CITY PLAN COMMISSION**THURSDAY, JANUARY 18, 2024****FILE NUMBER:** S234-035**SENIOR PLANNER:** Sharmila Shrestha**LOCATION:** between Carroll Avenue at Haskell Avenue, east of Central Expressway/
U.S. Highway No. 75 (FKA Keating Avenue)**DATE FILED:** December 21, 2023 **ZONING:** PD 305 (East Mixed Use Subdistrict E-2), PD 889**PD LINK:** [Article 305.pdf \(dallascityhall.com\)](#)[Article 889.pdf \(dallascityhall.com\)](#)**CITY COUNCIL DISTRICT:** 2**SIZE OF REQUEST:** 21.582-acres**APPLICANT/OWNER:** Urban Smart Growth, LP**REQUEST:** An application to replat a 21.582-acre tract of land containing part of Lot 1A and 1B, all of Lot 1C and 2A in City Block 18/2006 to create 5 lots ranging in size from 1.620 acre to 9.534 acre on property located between Carroll Avenue at Haskell Avenue, east of Central Expressway/ U.S. Highway No. 75 (FKA Keating Avenue).**SUBDIVISION HISTORY:**

STAFF RECOMMENDATION: The request complies with the requirements PD 305 (Subdistrict 2), PD 889 therefore, staff recommends approval of the request subject to compliance with the following conditions:

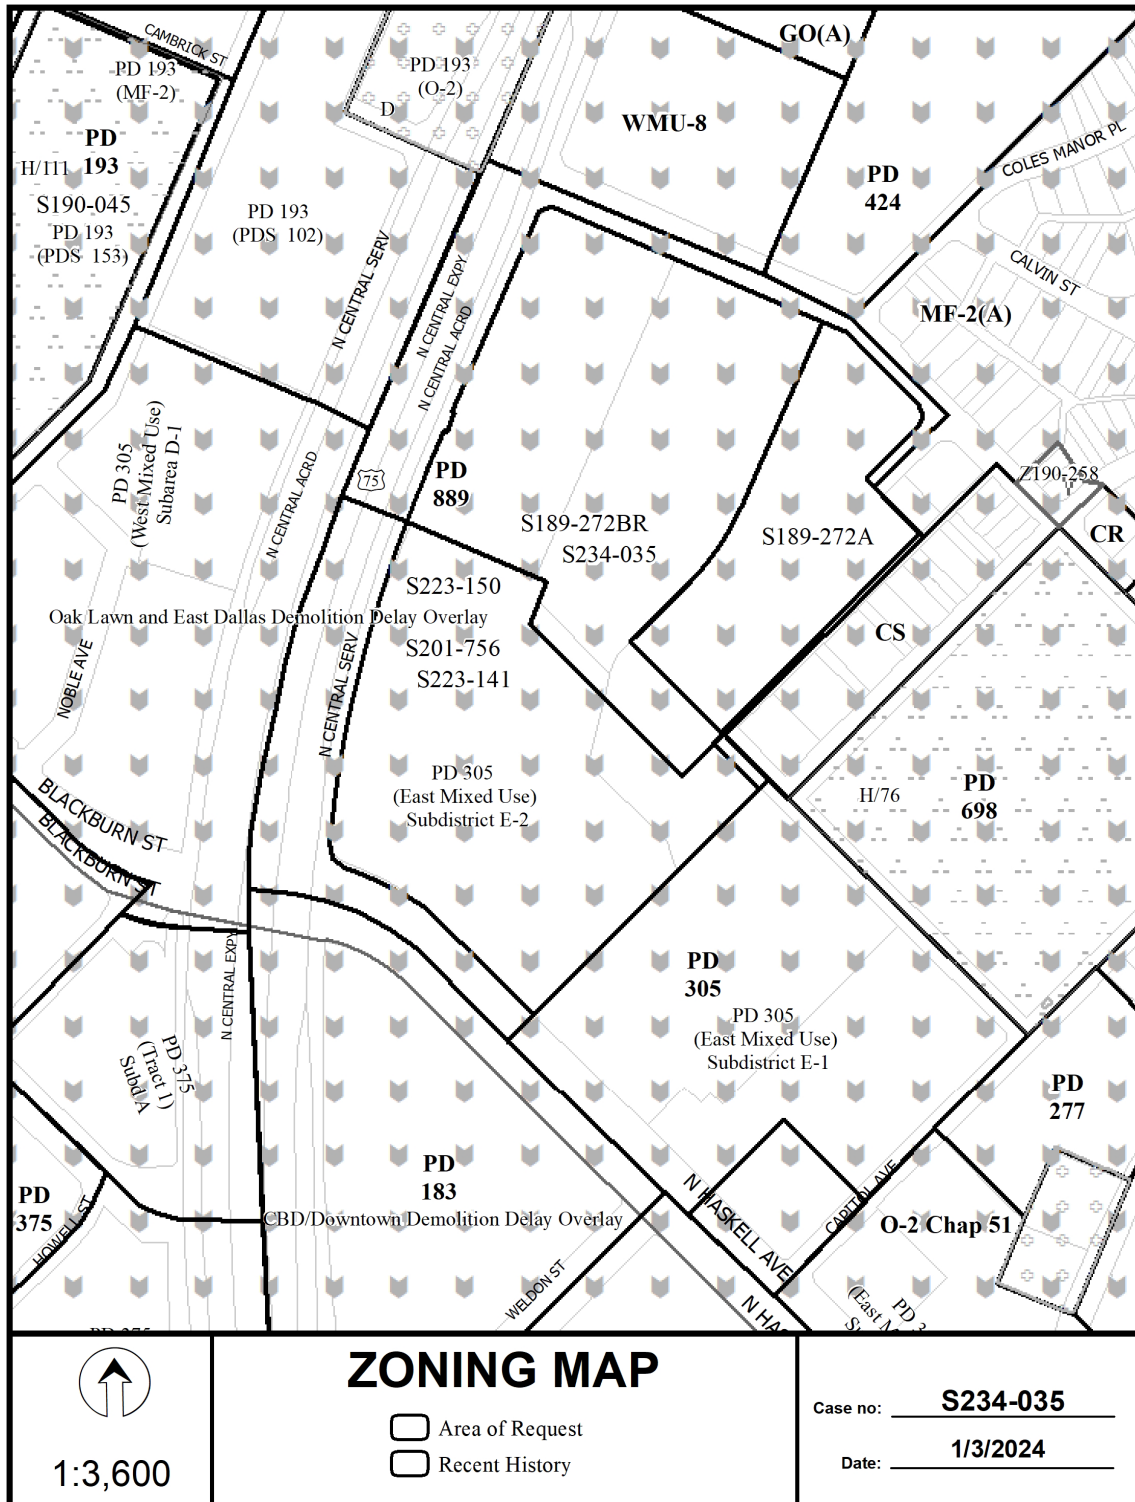
18. Prior to final plat, submit a completed final plat checklist and all supporting documents.
19. On the final plat, show the correct recording information for the subject property.
20. On the final plat, show how all adjoining right-of-way was created. Section 51A-8.403(a)(1)(A)(xxii).
21. On the final plat, show recording information on all existing easements within 150 feet of the property.

22. On the final plat, show all additions or tracts of land within 150 feet of the property with recording information.
23. On the final plat, list utility easements as retained within street abandonments when stated in the abandonment ordinance or follow the City of Dallas standard affidavit requirements.
24. On the final plat, chose a new or different addition name.

31. 15-foot water main easement and 20-foot water easement referenced "to be abandoned" and Inst. No. 202200195190 could not be accessed. If these easements have not gone through the abandonment process, application will need to be submitted to Real Estate division to process.

32. On the final plat, change "Central Expressway (US Highway 75)" to "Central Expressway/ U.S. Highway No. 75 (FKA Keating Avenue)".
33. On the final plat, change "North Peak Street" to "Peak Street".

34. On the final plat, identify the property as Lots 1E through 1H, and 1J in City Block 18/2006.
